2. AMENDMENT/MODIFICATION NO. **M004** 3. EFFECTIVE DATE (see block 16C) 4. REQUISITION/PURCHASE REQ. NO. **ADM-12-509** 5. PROJECT NO. if applicable

**Change Orders to One White Flint North Elevator Lobby/Restroom Refurbishment (OELRR) Project Phase II –
Floors 1, 3, 4, 6, 7, 8, & 15**

**US NRC
LOBBY & RESTROOM
RENOVATION**
 11555 ROCKVILLE PIKE
 ROCKVILLE, MD 20852

1 3RD-16TH (TYP) LOBBY & RESTROOM FINISH PLAN (EXCEPT 5TH AND 14TH FLRS.)
A6.1

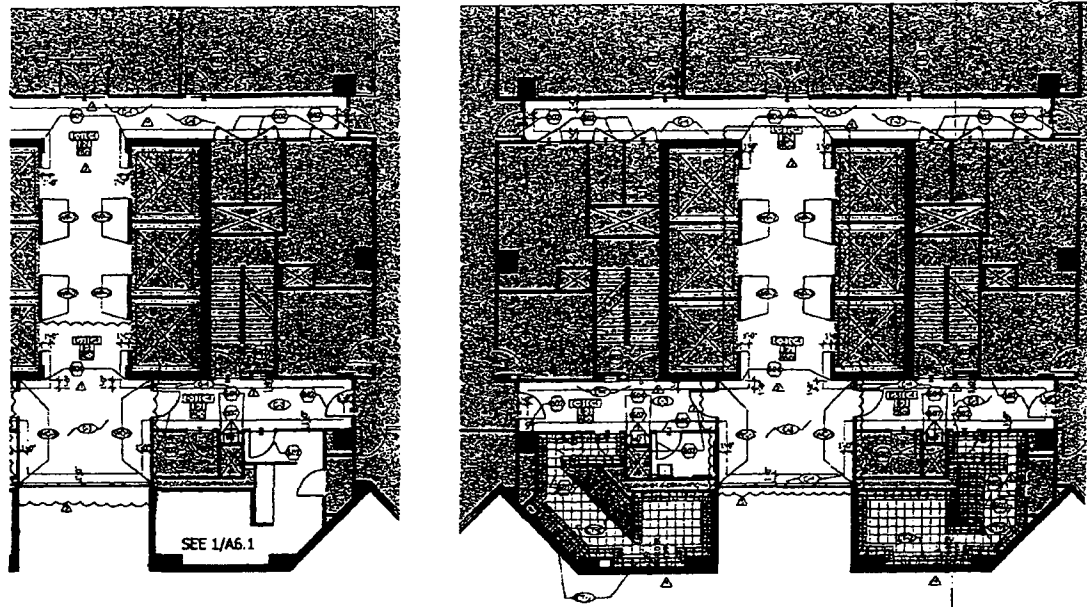
Change elevator field carpet as outlined in the attached drawing "OELRR 'A' Corridor Carpet Layout." The border carpet width was changed in 'A' Corridor and along the fire doors they were deleted.

7/17/12 Matt, Please install carpet per changes shown. Thanks, Jim [Signature]
